The Conservancy Association

27th September 2022

Comments on the Section 16 Application No. A/TP/684

Figure 1 The proposed alignment of sewer and manholes (marked in red) might be in direct conflicts with some retained trees

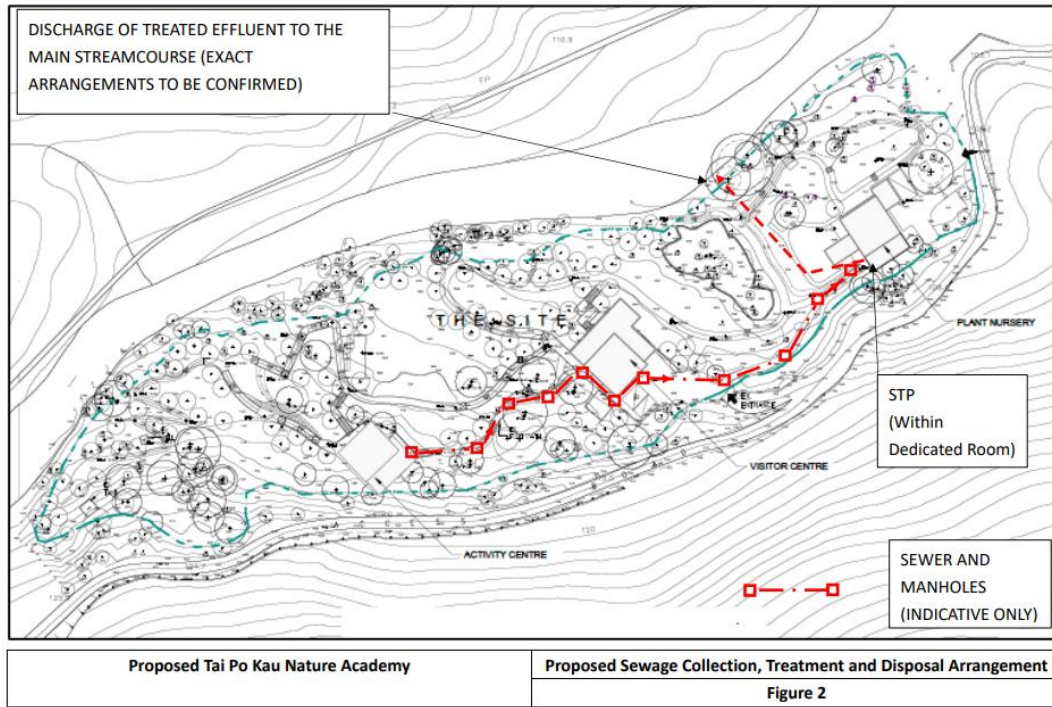
- Width of pathways within the proposed application site should be specified. This is to evaluate if there would be potential damage or truncation on tree roots during construction of various pathways.
- Figure 2 of Sewerage Impact Assessment (SIA) revealed that the proposed alignment of sewer and manholes might be in direct conflicts with some retained trees (Figure 1). It is necessary to evaluate if the number of felled trees has been

under-estimated, or if any other proper measures would be adopted, such as alternative alignment, designation of tree protection zone, etc..

Figure 2 The proposed discharge point of treated effluent lies within in direct conflict with T20 (*Cleistocalyx nervosum*) and close to T19 (*Ficus microcarpa*). That discharge point (marked in red) also lies within the proposed tree protection zones of both trees

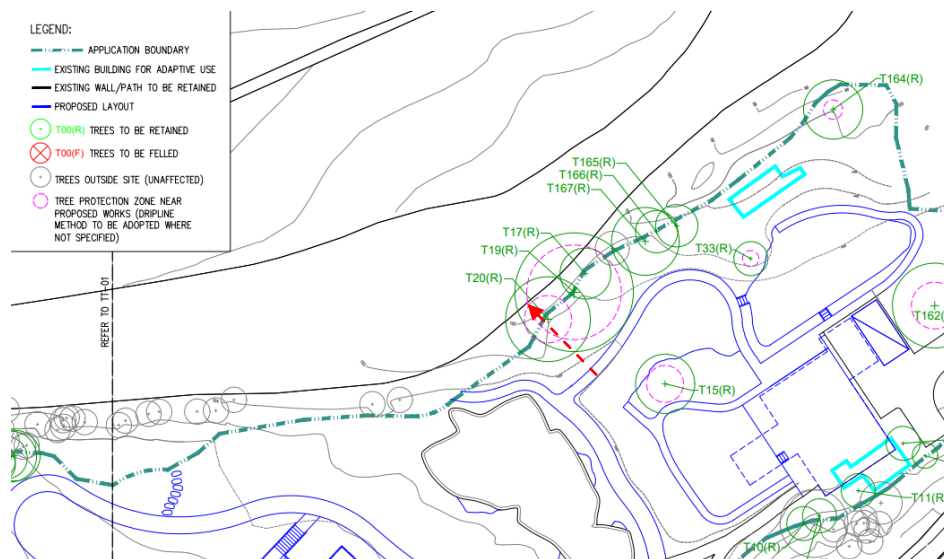
- SIA also revealed that the proposed discharge point of treated effluent lies within in direct conflict with T20 (*Cleistocalyx nervosum*) and close to T19 (*Ficus microcarpa*). That discharge point also lies within the proposed tree protection zones of both trees (Figure 2). We are concerned if works related to that discharge point would be commenced within these tree protection zones, how the tree protection zones can ensure proper protection of both trees.
- Figure 4.5 indicated that most of the pathways would be paved in wood deck. It would be grateful if the applicant can specify if concrete footing and column would be adopted. We hope to ensure that the design of pathway would not cause any damage on existing trees.
